REVISION TRANSMITTAL

This sheet transmits Revision 1 to SB680A-34-17 which:

NAVIGATION - INSTALLATION OF DUAL LITEF HYBRID NAVIGATOR UNITS AND RNP AR = 0.3 SOFTWARE

MODEL	SERIAL NUMBERS
680A (Citation Latitude)	-0001 thru -0247

Figure 1. Installation of the Dual Litef Hybrid Navigator Units and Configuration Modules (Sheet 1)

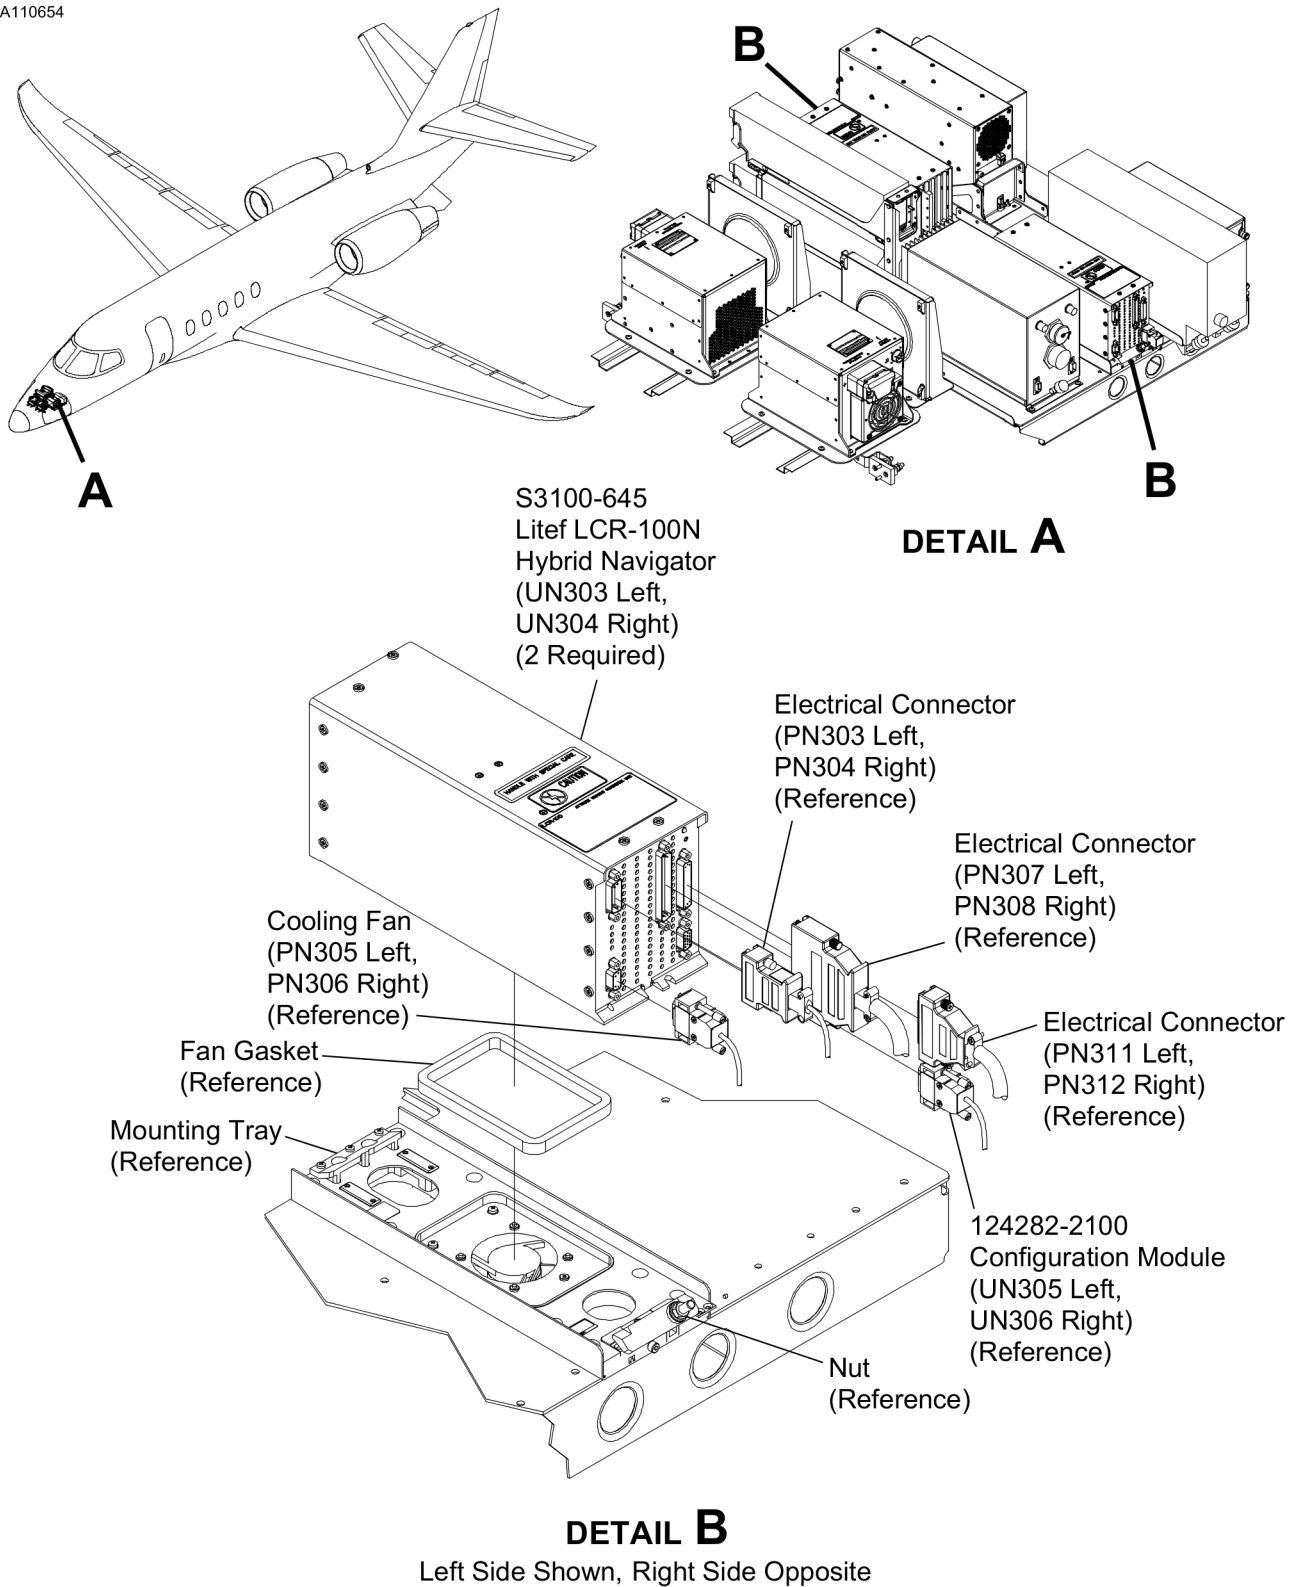
- A. Removed the instructions to remove the 124282-2100 Configuration Module from Step 2.
- B. Removed the instructions to install the 124282-2200 Configuration Module from Step 2.
- C. Removed the Adjustment/Test for the LITEF LCR-100N from Step 2.
- D. Added Step 3.
- E. Removed the 124282-2200 from the Material Information Section.
- F. Removed 124282-2200 Configuration Module from the illustration.

2. (Refer to Figure 1, Detail A.) Install the Upgraded Hybrid Navigators, do the steps that follow:
 - A. On aircraft with S3100-604 LCR-100N Hybrid Navigator Units installed, do the steps that follow:

- C. Install two S3100-645 Litef LCR-100N Hybrid Navigator Units (UN303 left, UN304 right). (Refer to Cessna Model 680A Maintenance Manual, Chapter 34, Litef LCR-100N Hybrid Navigator-Removal/Installation.
